**UNITED STATES OF AMERICA
NUCLEAR REGULATORY COMMISSION**

In the Matter of)	
)	
Duke Energy Florida, LLC)	Docket Nos. 52-029 and 52-030
)	
(Levy Nuclear Plant, Units 1 and 2))

DUKE ENERGY FLORIDA’S RESPONSES TO PRE-HEARING QUESTIONS

Downspout Screen Location

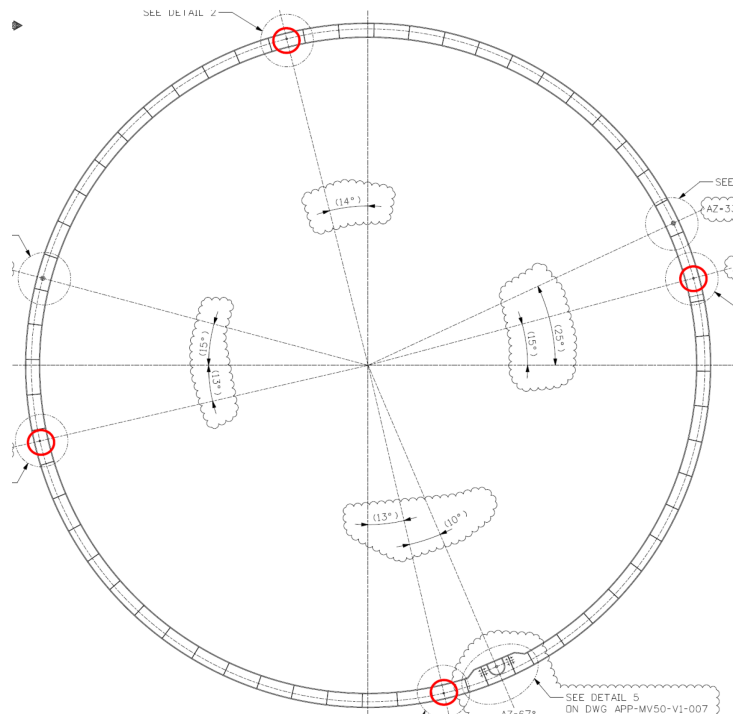
Question 25. As a part of LNP DEP 3.2-1 and LNP DEP 6.3-1, the applicant describes the addition of protective screens to the downspouts to protect the passive residual heat removal heat exchanger (PRHR HX) from debris. Has the applicant or the Staff investigated whether the screens could be subject to clogging phenomena similar to what is considered by Generic Safety Issue 191 (GSI-191)? Has the applicant performed any analysis to determine how long the PRHR HX can remain functional with degraded return flow to the in-containment refueling water storage tank (IRWST)?

When designing the downspout system and screens which interface with the polar crane girder (PCG) and the internal stiffener, plugging of one of the downspout screens was taken into

consideration to meet single failure criteria. Design calculations support downspout sizing and screen sizing considering a single failure (plugging of a downspout screen), and flowrates are shown to support adequate pressure drop to avoid overflowing at any one location while avoiding the potential for flashing in the system piping.

Related to their location in containment, the polar crane girder and internal stiffener are not easily accessible and are not located in high traffic areas which may result in potential cleanliness issues that may plug any of the screens. The four screens added at the polar crane girder and internal stiffener are evenly spaced around containment to provide separation between each of the downspout connections. The figure below provides detail as to the location of the screens at the internal stiffener elevation.

Figure: Polar Crane Rail and Dam

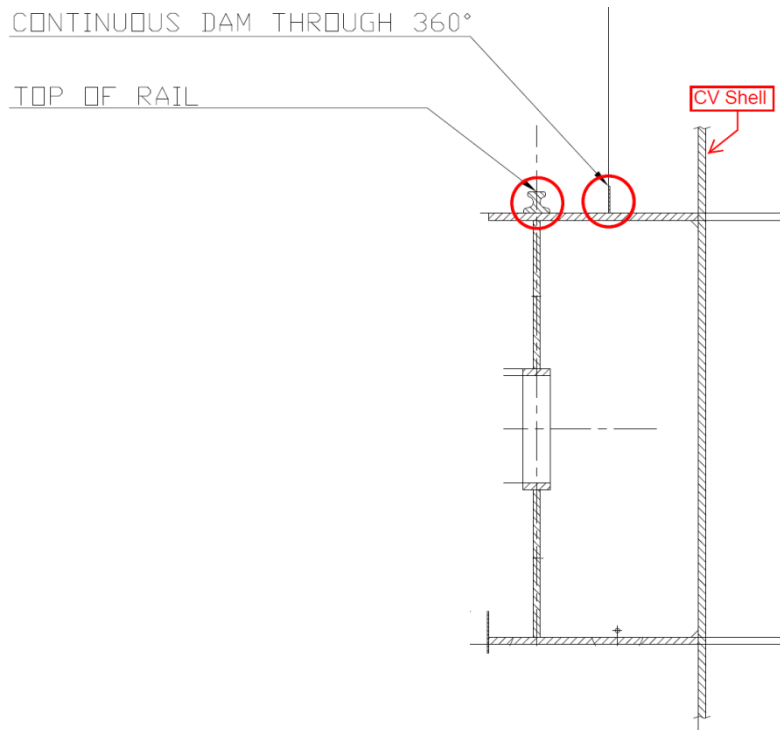
Question 27. As part of the exemption for DEP 3.2-1 related to the passive core cooling system (PXS) containment condensate return, Technical Specification (TS) Surveillance Requirement 3.5.4.7 was added to require a visual inspection of the IRWST gutter and downspout screens to verify that the return flow to the IRWST will not be restricted by debris.

The Staff's technical evaluation of the exemption request and departure states, "Condensate return is one of the primary factors influencing the performance of the PRHR HX." The Staff further explains that the PXS downspout piping network was added at the polar crane girder and stiffener with four specific collection points located on both the upper portion and the

The position of the polar crane on the girder has no impact to the rate of condensate return. The rail that the polar crane rides on is located several feet from the containment vessel shell, and goes around the entire circumference of containment. The dam which was added on the polar crane girder is located between the containment vessel shell and the polar crane girder rail. Therefore, any condensation which occurs on the containment vessel shell and travels down the shell to the polar crane girder collection location will be separated by the dam from any interaction with the polar crane itself. Any condensation which occurs on the polar crane and/or the polar crane structure that spans from one side of containment to the other will not be captured by the gutter system. This is accurately modelled in WGOTHIC as a heat sink, and therefore no credit is taken for capturing this lost condensation. The Figure below shows an image of the continuous dam and also the rail for the polar crane.

In the Figure above, the polar crane rail and the continuous dam are circled. The containment vessel shell is pictured at the right of the figure. Therefore, based on the orientation of the polar crane circumferential dam, there is no need for a Technical Specification or Surveillance Requirement restricting the polar crane bridge position on the girder.
